California High-Speed Train Project

TECHNICAL MEMORANDUM

Design Variance Guidelines TM 1.1.18

CALIFORNIA HIGH-SPEED TRAIN PROJECT
DESIGN VARIANCE REQUEST

Figure 1: Additional Property Impacts, Second Street

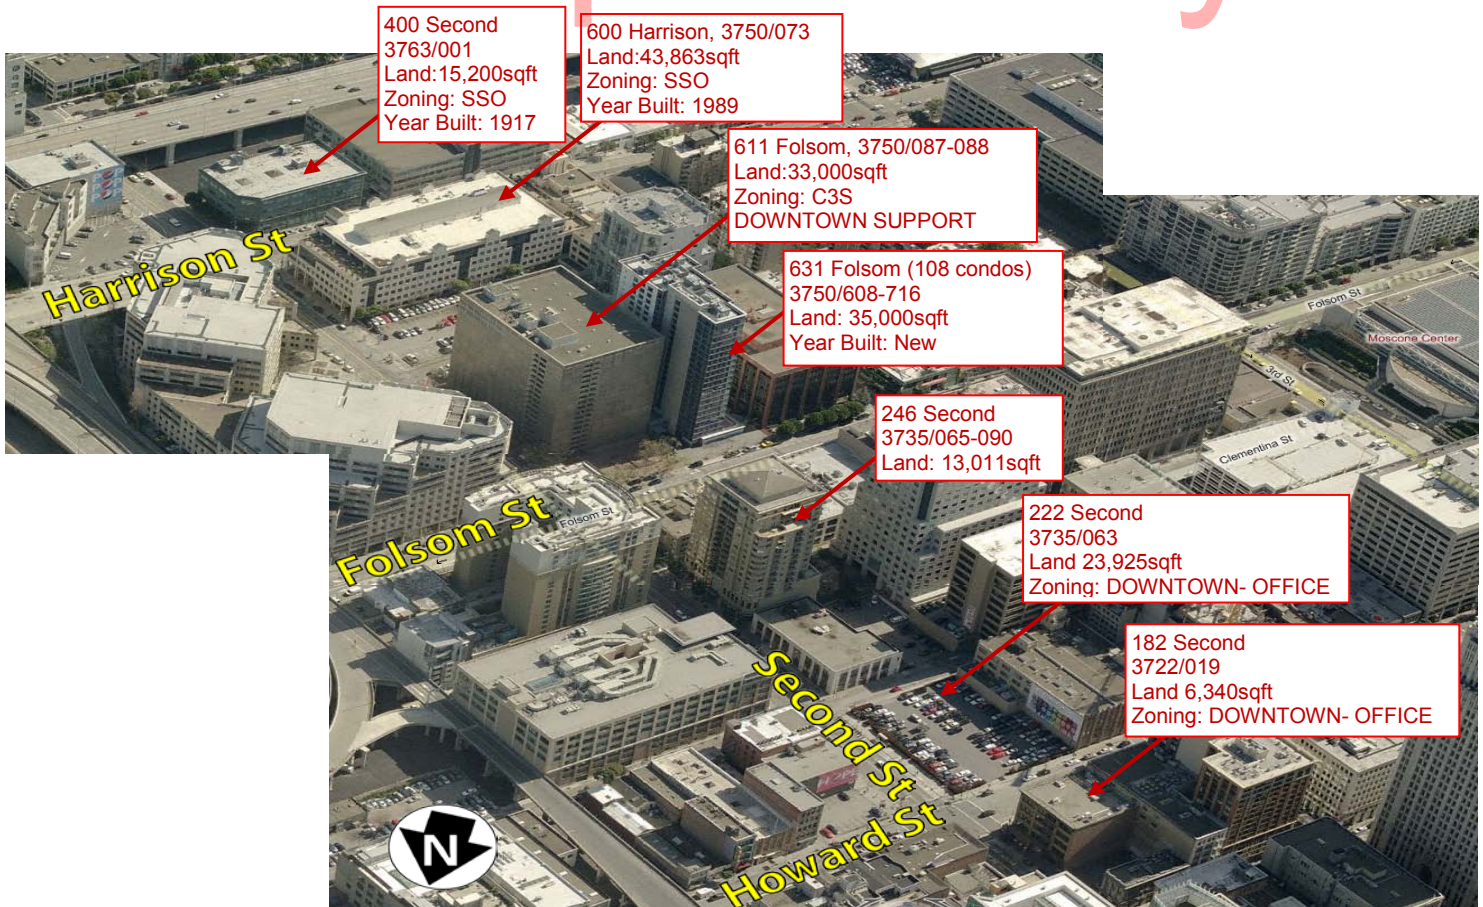
Properties not currently identified for acquisition which would be impacted by accommodating CHSTP criteria for platform approach tangent length are indicated in Figure 1 below. Costs associated with the acquisition of these properties and the relocation of owners is provided in Table 1.

Enc: TTC Track Configuration Drawing, dated September 20th 2010

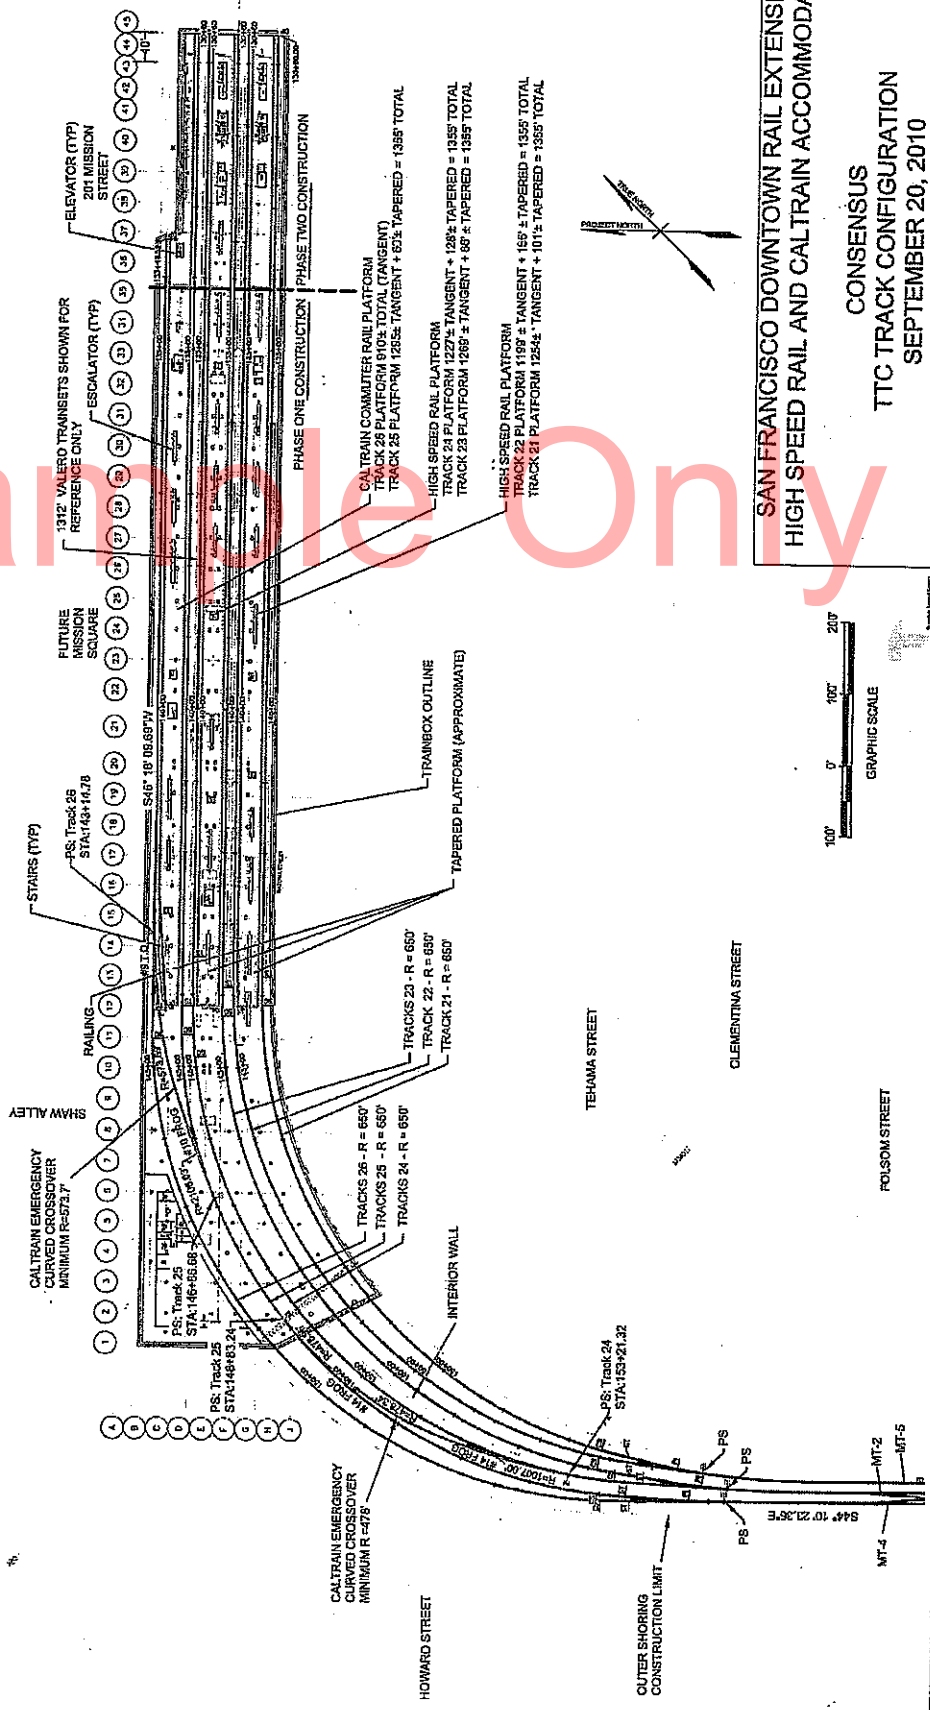
More specifically, it is understood that the attached exhibit is a preliminary drawing and further design is required to address areas where engineering variances are required. Specific variances required for the CHSR platforms were indicated in a letter by Parsons Brinkerhoff dated August 27th, 2010 (Reference PB-TJPA-1127). In addition, engineering variances will be required by Caltrain for the crossovers required in the curved portion of the terminal approach; the reduced width of platform on Track 25 near the end post; and the tapered end of platform on Track 26- understood to be outside of the usable portion of vehicle berthing.
